DART A/C Air Intake Grill Change

Property name and Top bus number: DART - 304500

Issue: A/C Grill Rusting

4 bolts that need to be removed. Old grill to be removed

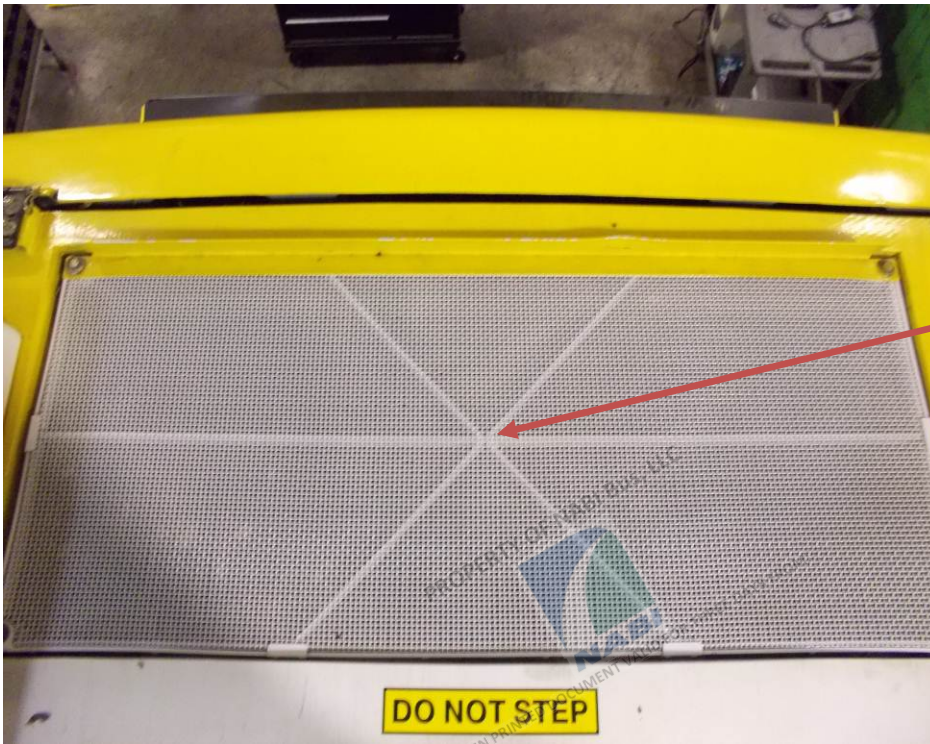
Reason/ cause: Not painted properly

1. Park the bus and apply the parking brake.
2. Turn off main battery disconnect switch(es)
3. At the rear of the bus on the roof at the A/C grill remove the 4 bolts that hold the grill in place.
4. Remove the grill and put the new grill in place put the 4 bolts back.

Solution: Replace the grill with painted grill.
